Improved Seal Housing Design for Turbine Pumps (All Models 10, 12, 13, 14, 16, 17, 18, and 19)

Corken has made the following design improvements to the seal housing. Effectively immediately the pump shaft hole on the back of the seal housing has been enlarged to 7/8" diameter and all turbine pumps built with Buna-N, Viton^{®1}, and Neoprene^{®1} O-rings are being shipped without a pin in the back of the seal housing.

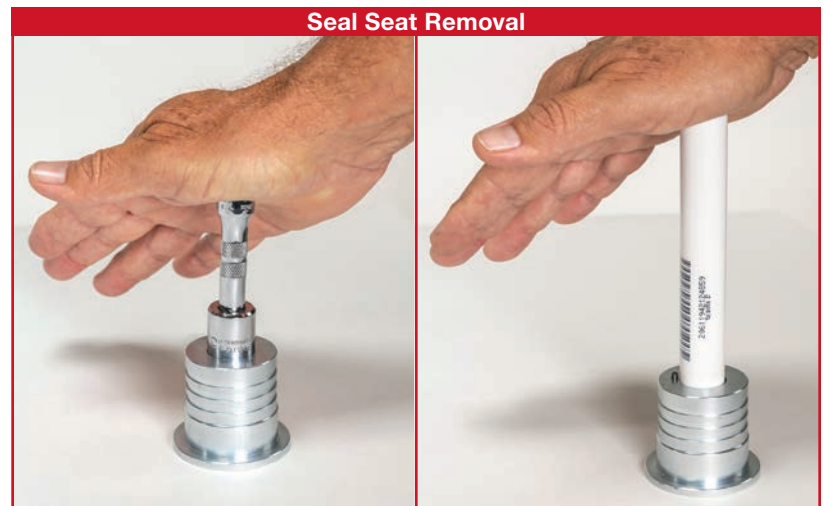
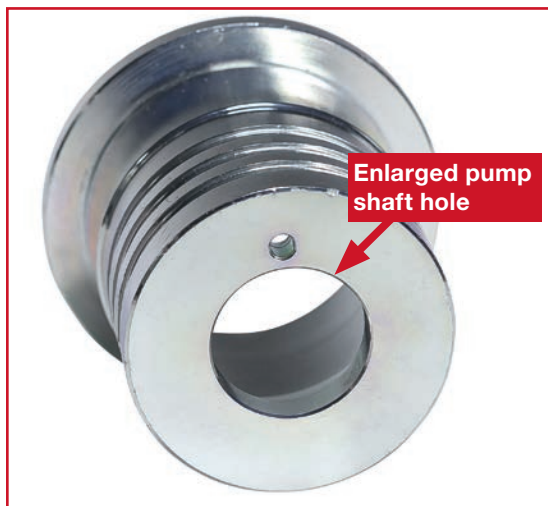
Change: The pump shaft hole on the back side of the seal housing has been enlarged.

Benefit: The old or new silicon carbide seal seat can be quickly removed from the seal housing with a 3/8" drive socket or a piece of 1/2" PVC piping without causing damage to the seal seat.

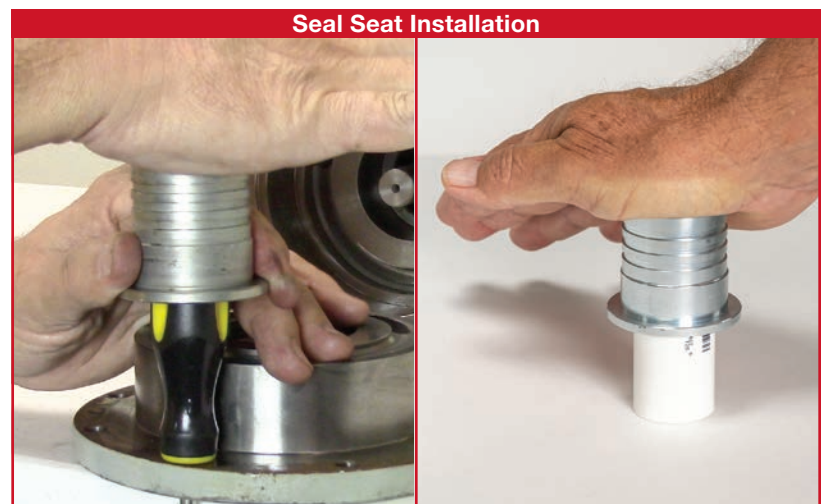
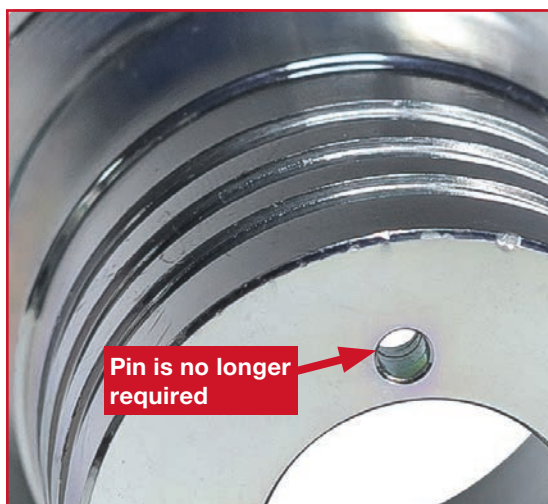
Change: A pin is no longer installed in the back side of the seal housing on pumps built with Buna-N, Viton^{®1}, and Neoprene^{®1} O-rings.

Benefit: When installing a new silicon carbide seal seat inside the seal housing, pin alignment is no longer required so installation is faster and damage to the seal seat is minimized when using a plastic handle screwdriver or 3/4" PVC collar.

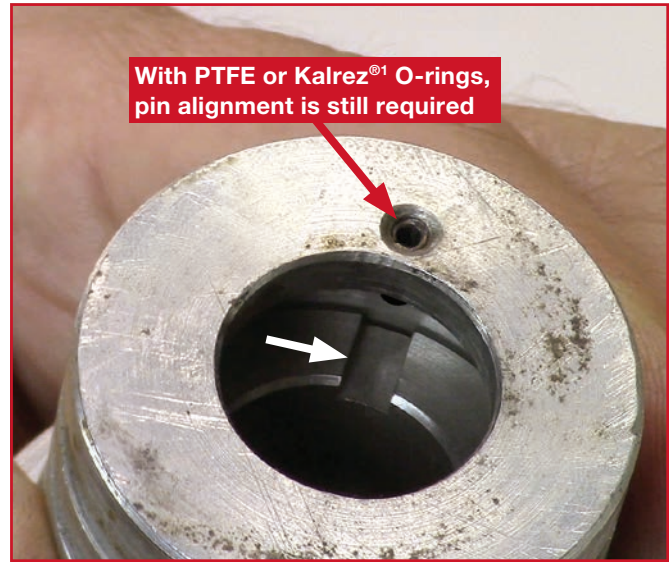
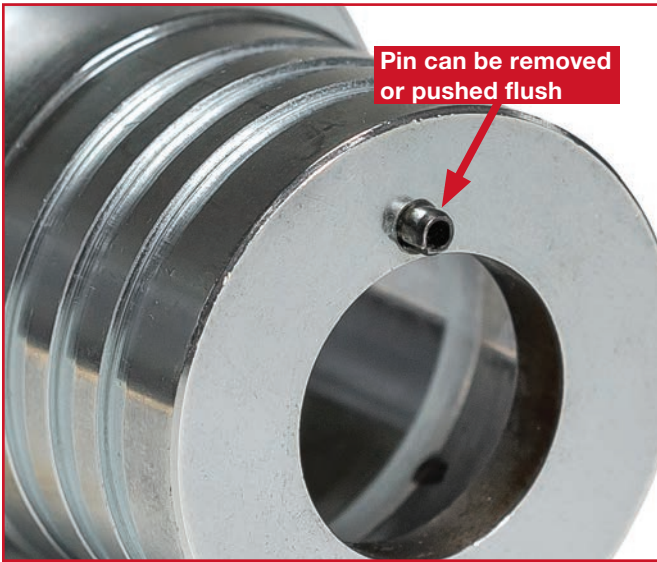
When it becomes necessary to replace the silicon carbide seal seat in turbine pumps built with Buna-N, Viton^{®1}, and Neoprene^{®1} O-rings prior to this design change, the pin can be removed or pushed in flush with the inside of the seal housing. When the pin is not used, it will extend out the back side as shown.

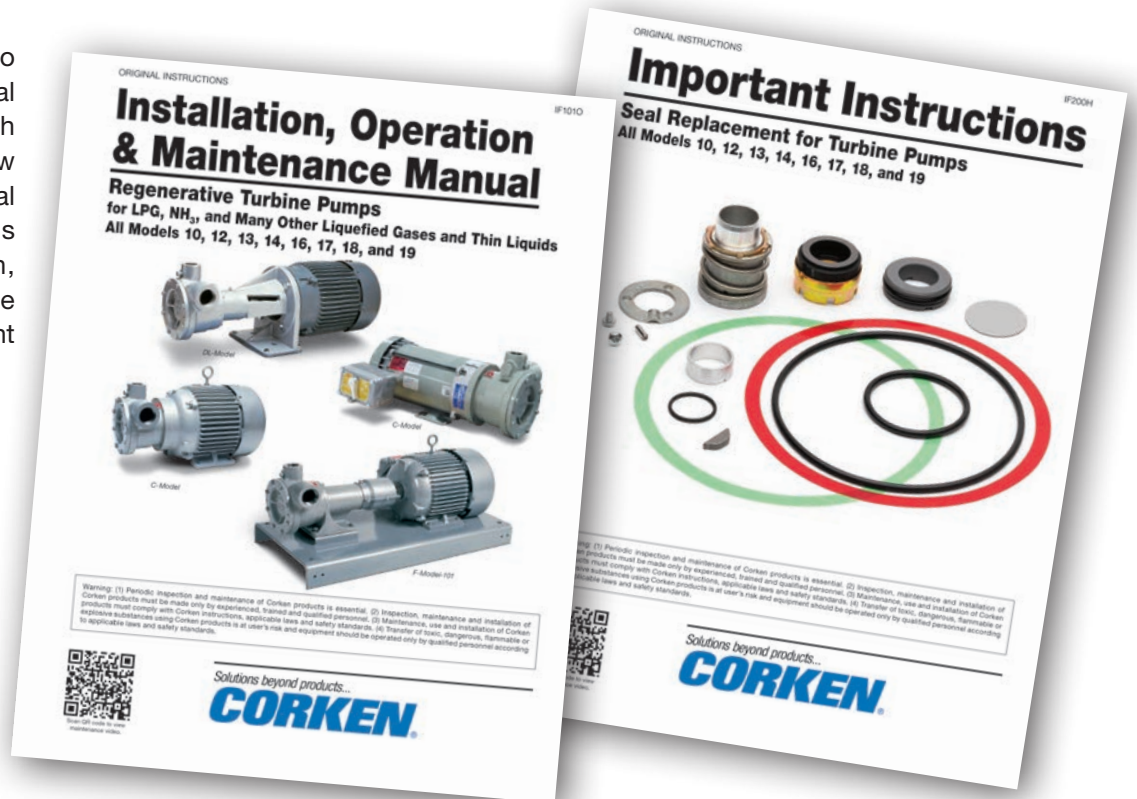
NOTE: All turbine pumps built with PTFE or Kalrez^{®1} O-rings still use a pin in the back of the seal housing so pin alignment is required. With these O-rings materials, tests have shown the seal seat can rotate if the pin is not used causing premature wear to the seal housing.
